PROJECT: Washington Street Improvement Project, Main Street to  
Vista Drive  
City Project Number ST2015-08

**ADDENDUM NO. 2**  
**To the Contract Provisions for**  
**CITY OF FERNDAL, WASHINGTON**

**Washington Street Improvement Project**  
**Main Street to Vista Drive**  
**City Project Number ST2015-08**

**ADDENDUM NO. 2**

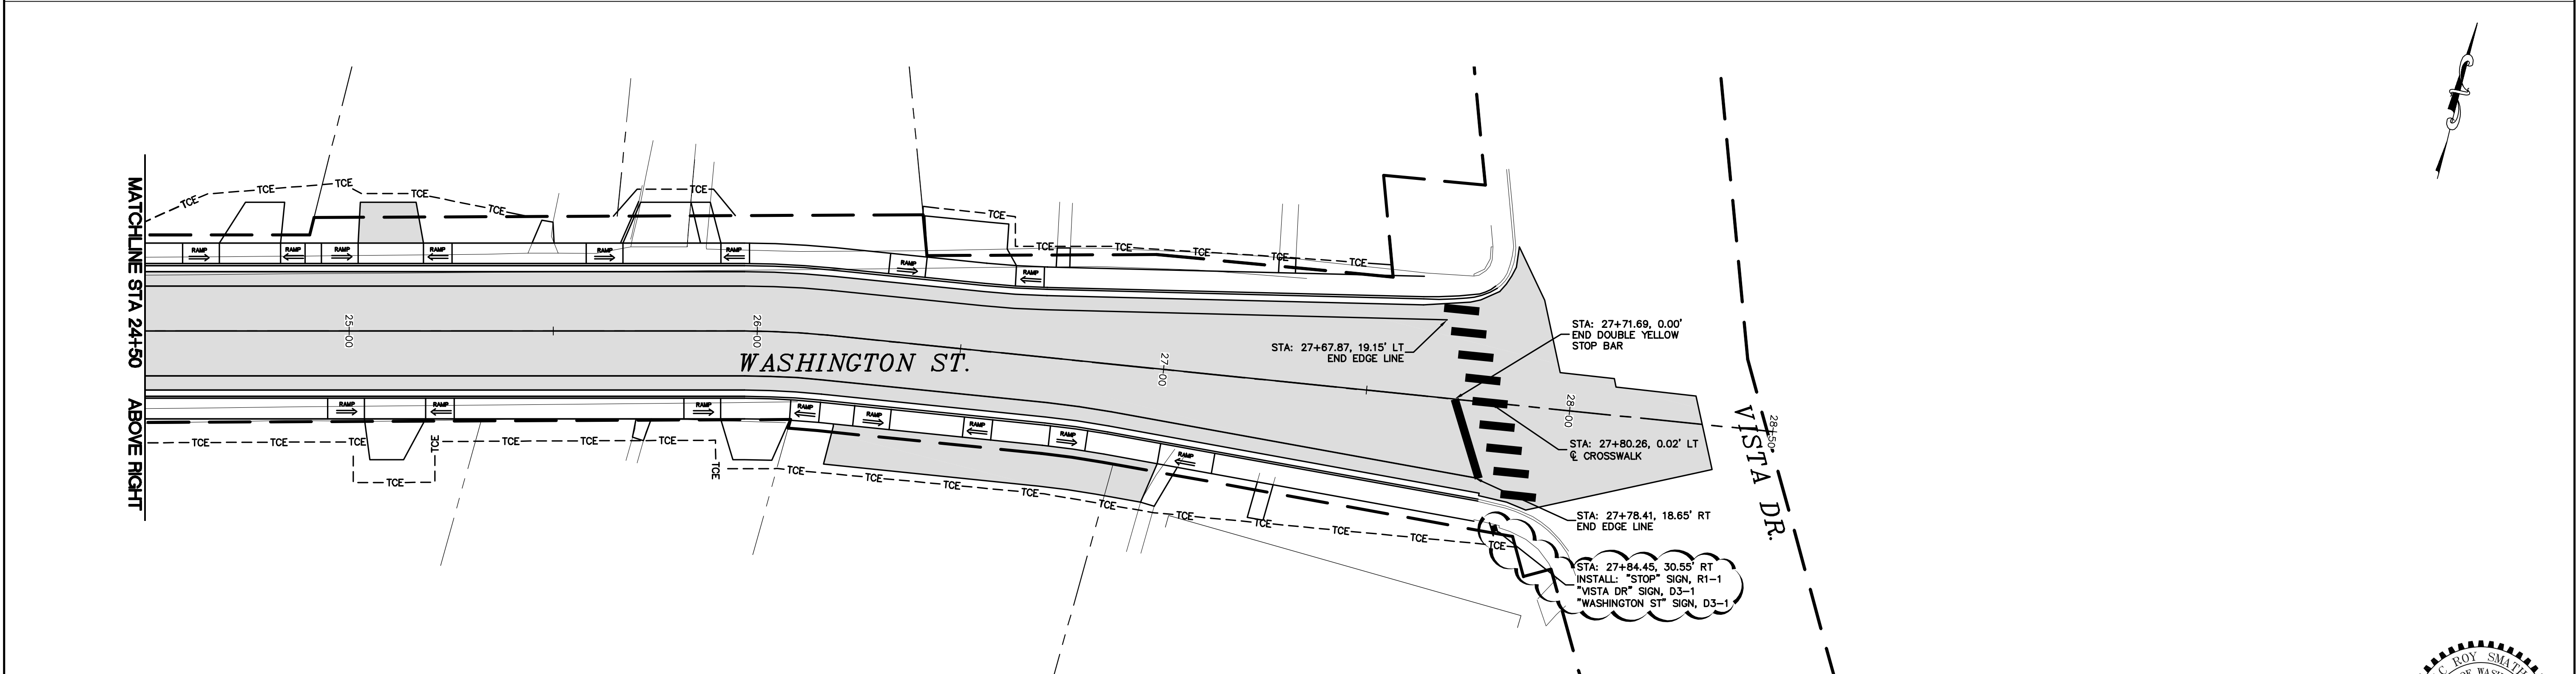
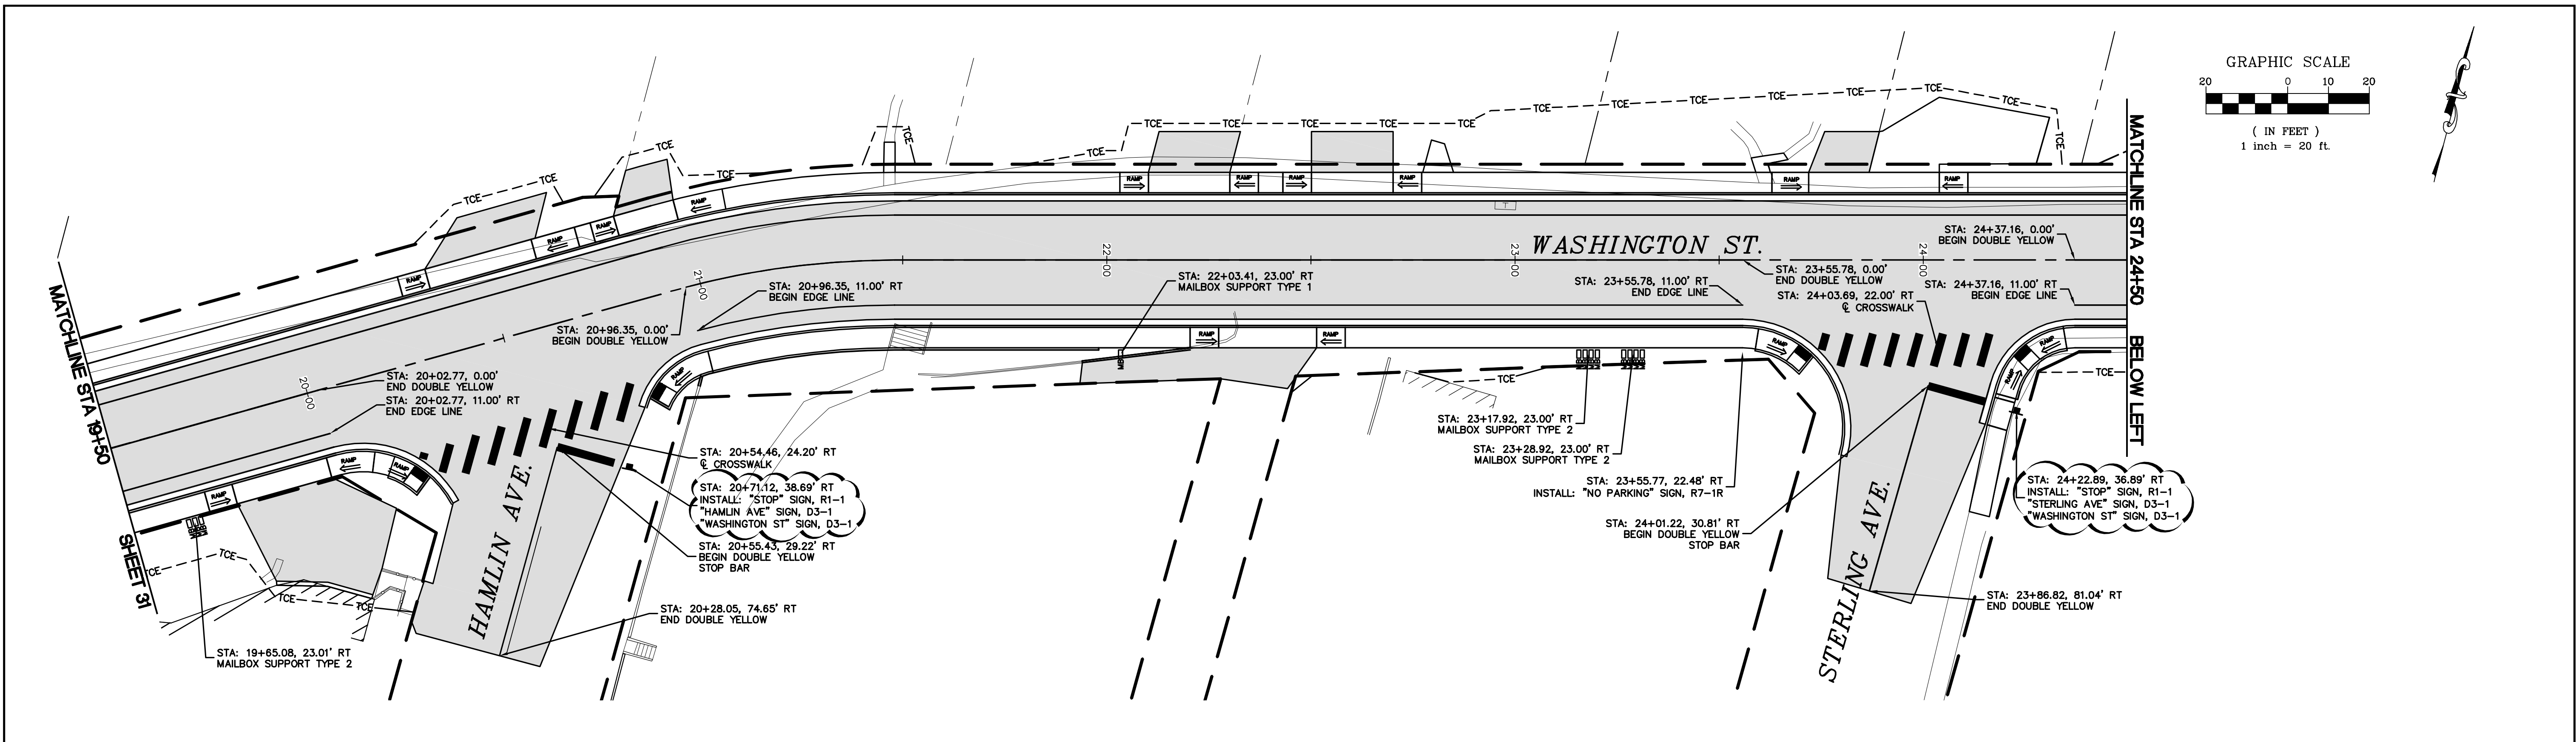
**Plan Sheet 32**

The installation of the street signs at the intersections of Hamlin Avenue and Washington Street as well as Sterling Avenue and Washington Street are now labeled. The installation of a stop sign and street signs at the intersection of Washington Street and Vista Drive has been added and labeled.
